SUPPLEMENTARY MACHINE SERVICE BULLETIN No. 108-A

SUBJECT: Plus, Minus and Shift Key Locks-
KAE and KASC Models.

DATE: July 16, 1931

FIG. 1.

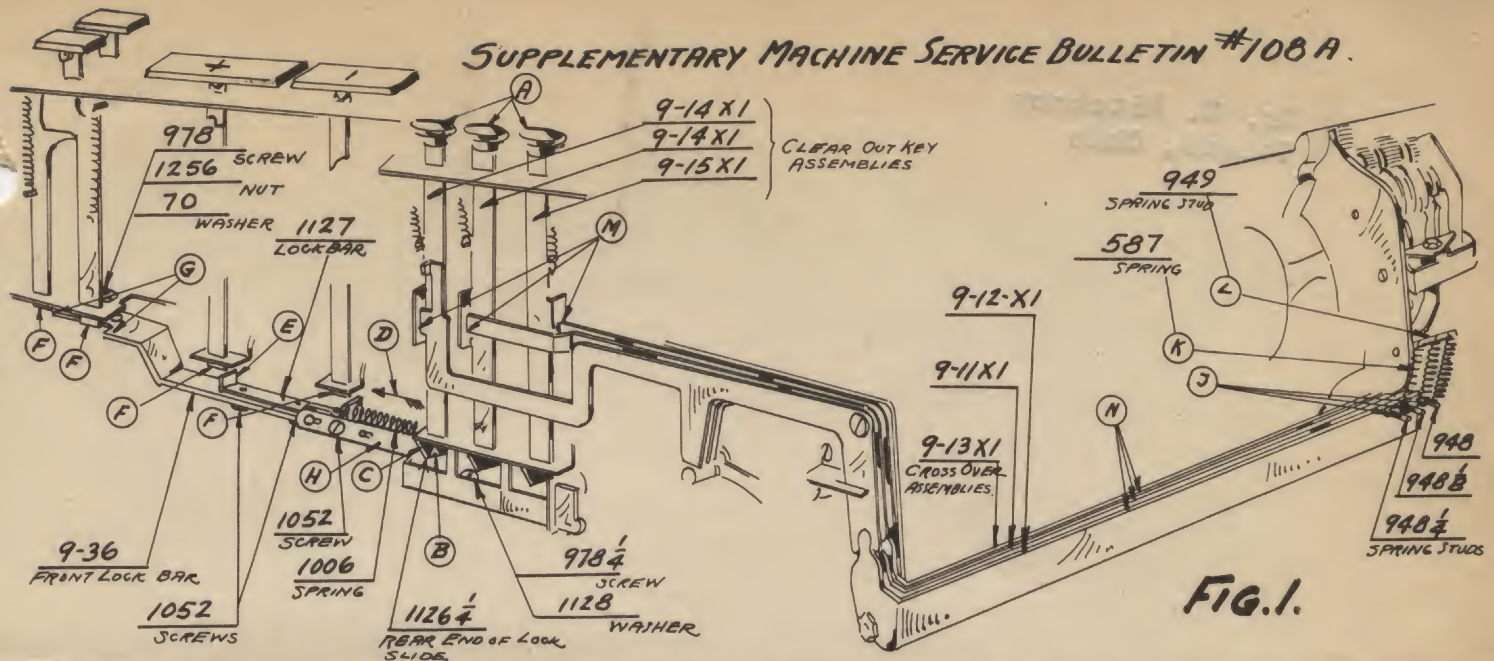
We now have in production a new style locking device for the purpose of locking the plus, minus and shift keys against depression while the dial clearing keys mechanism is functioning. This is now standard equipment in all machines being manufactured of these models.

ABOVE IS SHOWN THE FUNCTIONING OF THE LOCKING DEVICE FOR THE PLUS AND MINUS AND SHIFT KEYS-DEPRESSION OF ANY KEY (A) FORCES END (B) AGAINST INCLINED SURFACE (C) THUS FORCING LEVER (H) REARWARD IN DIRECTION OF ARROW (D) - THIS LEVER (H) CONTAINS TWO BLANKS (E) AND (G) WHICH CONTAIN SURFACES THAT SERVE TO LOCK THE KEYS (F) BY CONTACT AGAINST DEPRESSION.

NOTE - CROSS OVER LEVERS (N) HAVE BEEN PROVIDED WITH 3 SPRING POSTS (J) THESE POSTS HOLD 3 SPRINGS (K) TO PIN (L) IN THE GEAR CASE - THIS RESULTS IN A MORE POSITIVE CONTROL OF THE NOSES IN RELATION TO THE PAWLS IN THE DRUMS.

NOTE - ADDING THE SPRINGS (K) AND THE CLOSING OF SLOTS (M) IN KEYS (A) HAS ELIMINATED THE NECESSITY OF LOCKS (BB) SHOWN ON PLATE 22 BULLETIN #108

Remove bracket 9-28, locate drill jig #1 on it and drill clearance hole for 978 screw with #28 drill.

Remove lock bar 1527, guide blank, 1526, and start and stop switch. Scrap lock bar 1527.

Locate drill jig #2 on pin post 1051 on the 9-10 assembly, drill hole with #32 drill and tap with 6/40 thread.

Tilt machine upward and drill a hole in guide blank 1525 with #50 drill for spring 1006, or remove blank 1525 and drill the hole.

This mechanism can now be assembled and adjusted as illustrated and explained in figures #1 and #2 of this bulletin.

FIG. 2

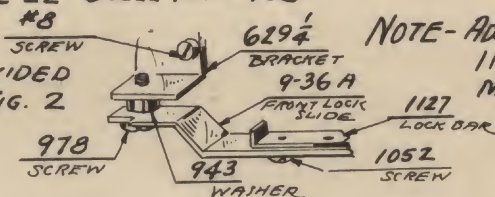
NOTE - ADJUSTING SCREWS 1052 IN LOCK BARS 1126 1/4 - 1127 - ARE PROVIDED SO THAT THIS MECHANISM MAY BE ADJUSTED TO SUIT.

FIG. 3

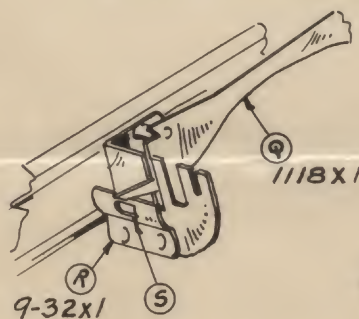
Figure 3 of this bulletin illustrates and describes a change in design that was made to overcome the possibility of the carriage shifting the wrong way when the right-hand shift key is operated.

THE ABOVE CHANGES IN DESIGN HAVE BEEN MADE TO OVERCOME THE DIFFICULTY EXPERIENCED ON ACCOUNT OF THE CARRIAGE SHIFTING THE WRONG WAY WHEN THE RIGHT-HAND SHIFT KEY IS DEPRECATED. (FIG. 3.)

This mechanism can be incorporated, where required in KASC models, in the field as it is only necessary to remove rivet #1076 (not shown) and blank #1118 on the 9-23 assembly, and replace it with blank #1118xl, and to replace the 9-32 assembly with 9-32xl, shown as (R).

FIG. 3A

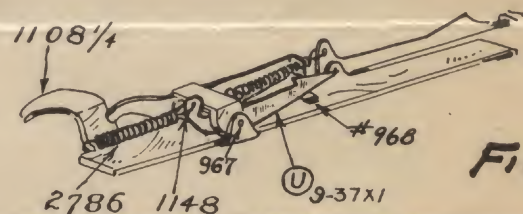
THE CHANGE IN BLANK (Q) AND THE ADDITION OF PART (R) HOLD THE ENGAGEMENT OF BLANK (Q) WITH PIN #968 IN FRONT SHUTTER SHIFT BAR #9-19 ASSEMBLY (FIG. 3A)

THE SLOT (S) IN BLANK (R) IS PROVIDED SO THAT BLANK (Q) CAN PERFORM ITS NORMAL FUNCTION WHEN THE LEFT HAND SHIFT KEY IS DEPRECATED

THE ADDITION OF LATCH (U) - 9-37x1 ASSEMBLED AS SHOWN TO #9-19 ASSEMBLY CAUSES AN ENGAGEMENT BETWEEN IT AND #9-32x1 WHICH PREVENTS THE CARRIAGE FROM SHIFTING TO THE RIGHT IN AUTOMATIC DIVISION.

Figure 3A - Latch U, 9-37xl, can be assembled to the 9-19 assembly by removing pivot pin 967 and omitting spacer 1148, and attaching its tension spring 2786 to blank 1108 $\frac{1}{2}$ on the 9-19 assembly as shown. The addition of this latch (U) causes an engagement between it and the 9-32xl which prevents the carriage from shifting to the right in automatic division.
